ADDENDUM TWO

PROJECT NAME: Village Court Apartments Phase IV
415 Mountain Village Blvd
Mountain Village, Colorado

DATE OF ADDENDUM: 08/26/19

Reference details 7/A4.01E and 7/A4.02W and 5/S3.2:

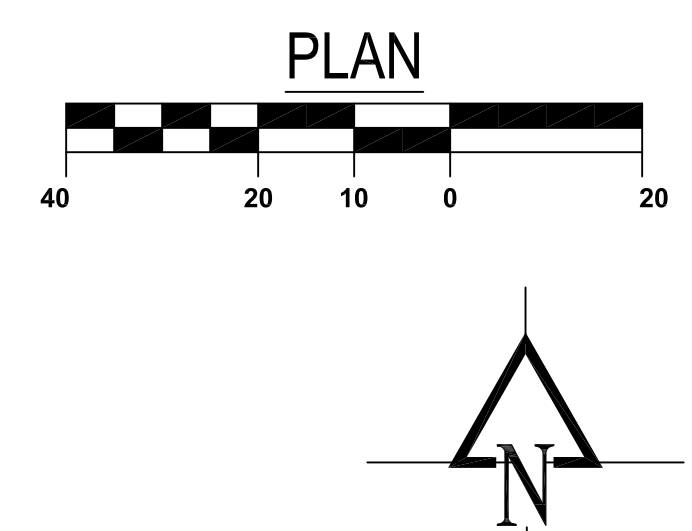
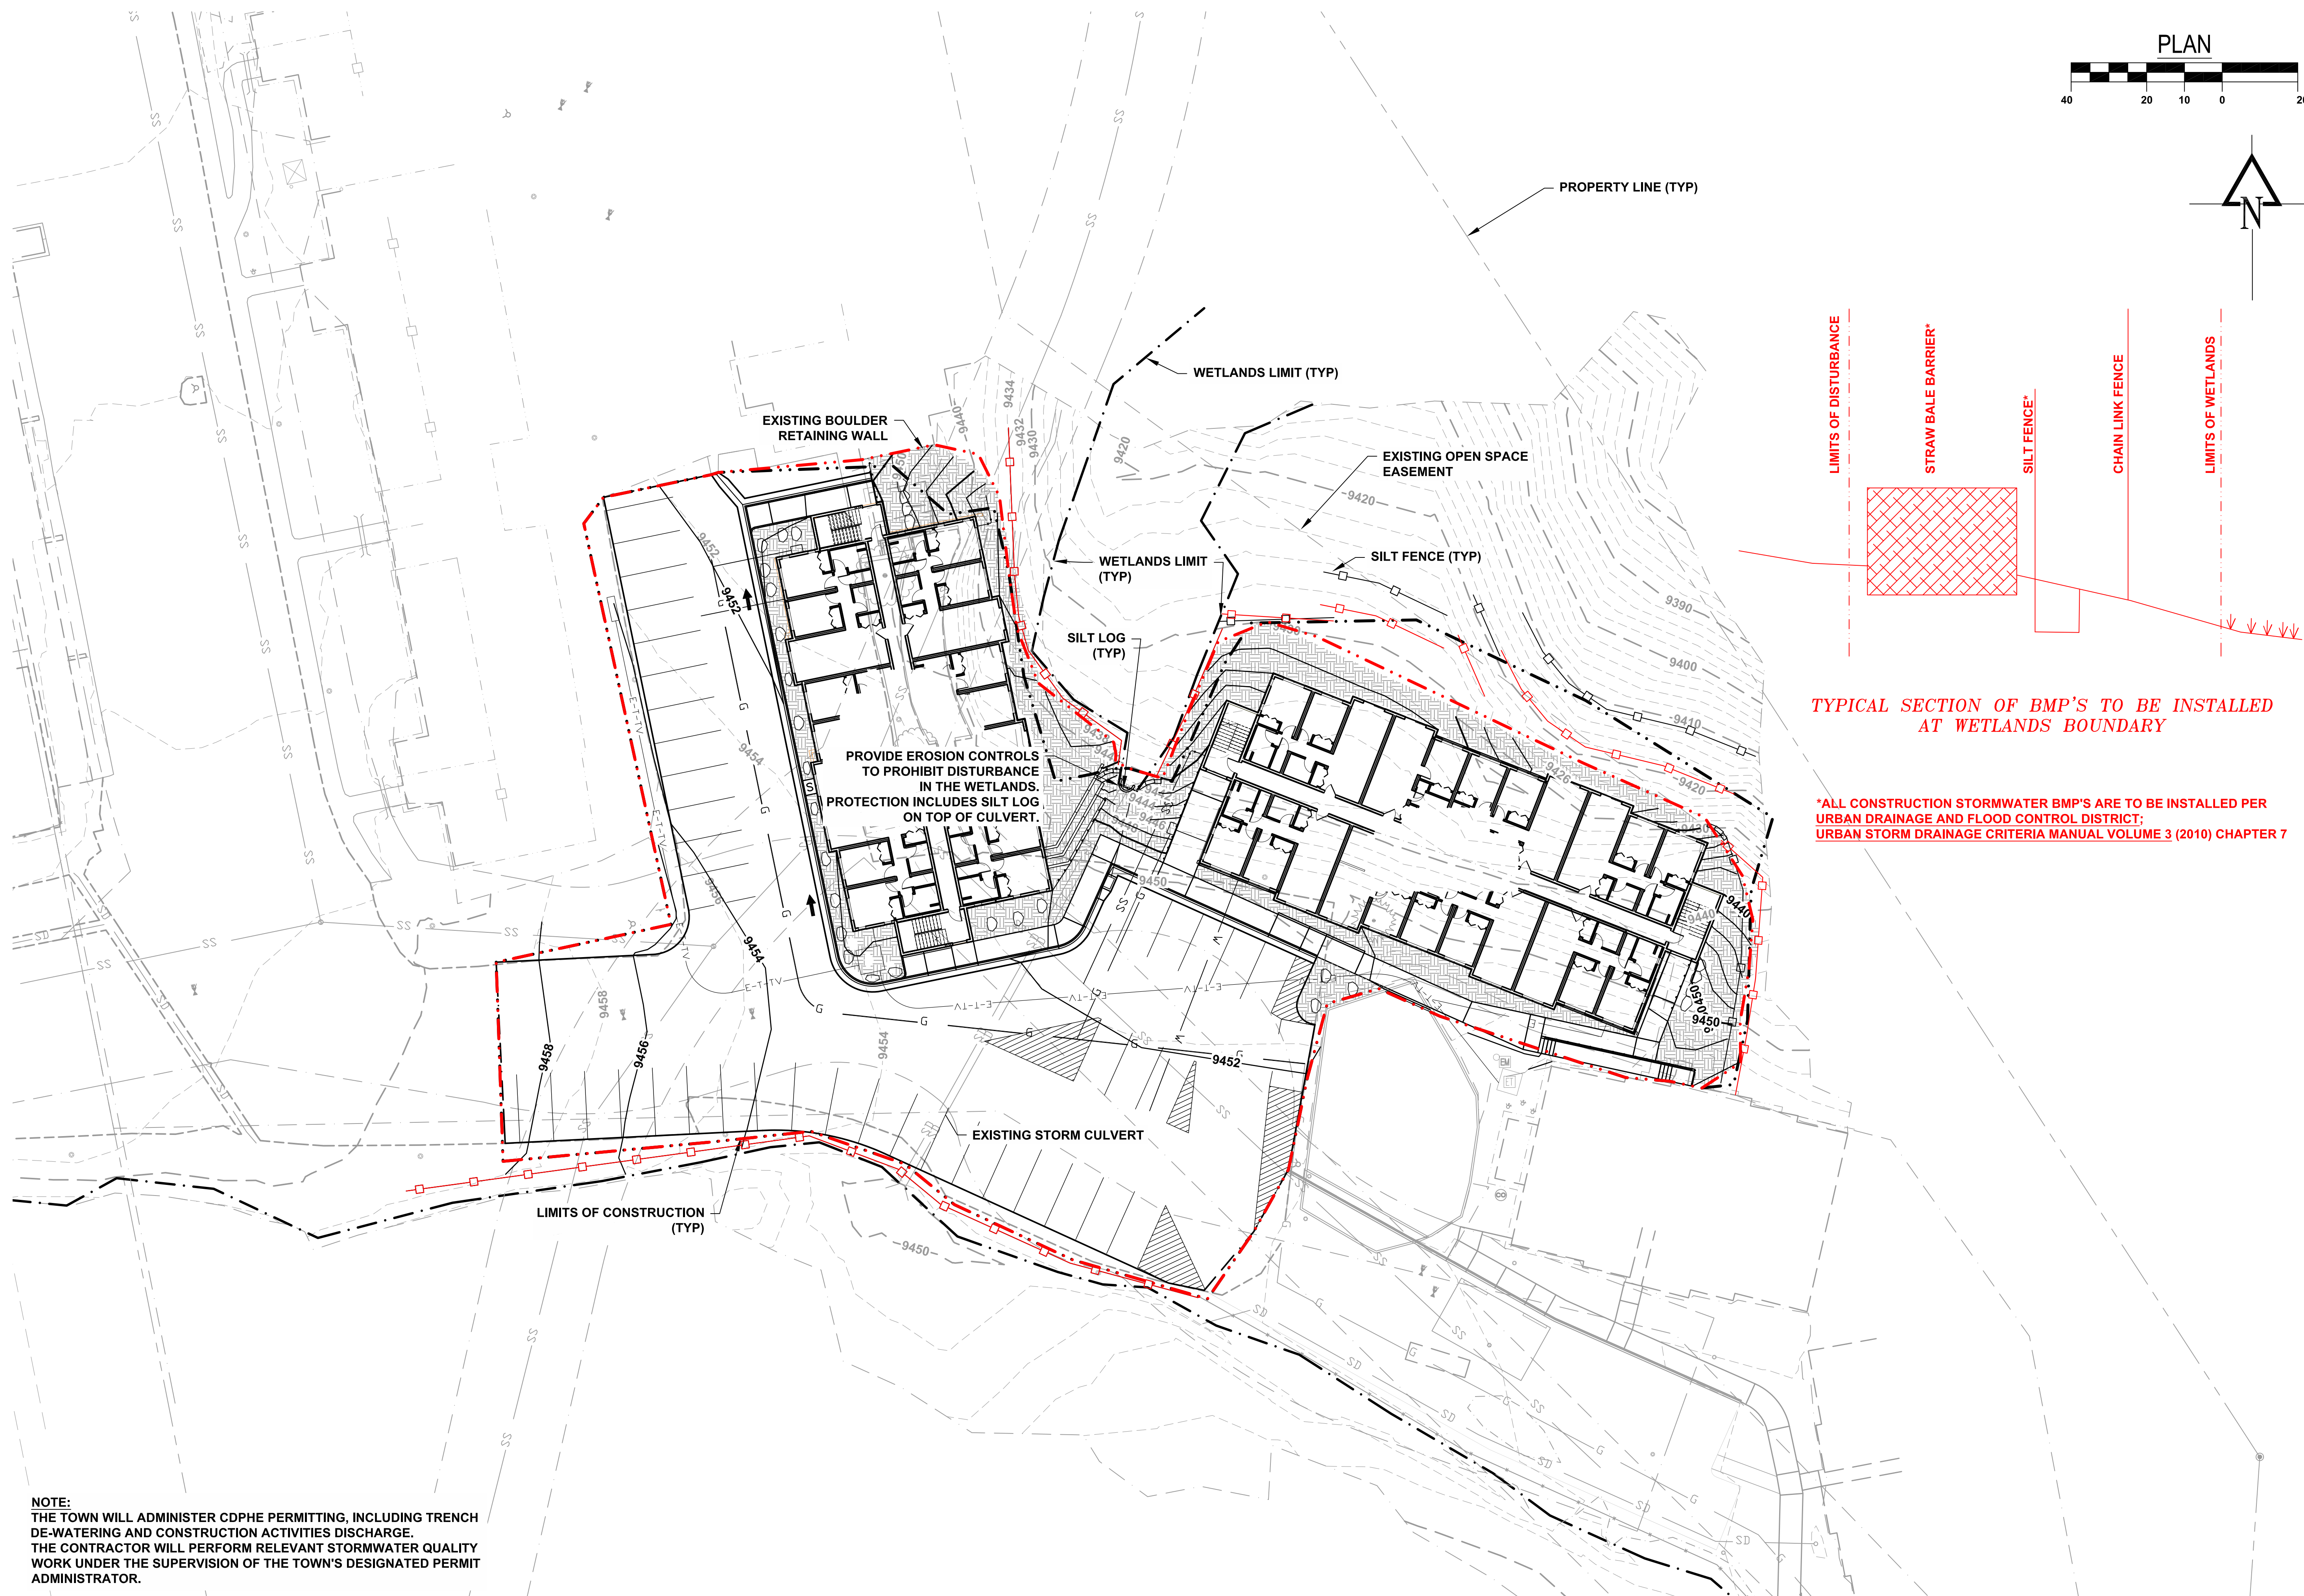
The architectural details call for 4x16 Timber stair stringers and 4X14 Timber stair treads.

The structural detail calls for 4X10 Timber stair stringers and 4X12 Timber stair treads.

Which is correct?

Response: The structural details are correct. The stair stringers are to be 4x10's and the treads are to be 4x12's.
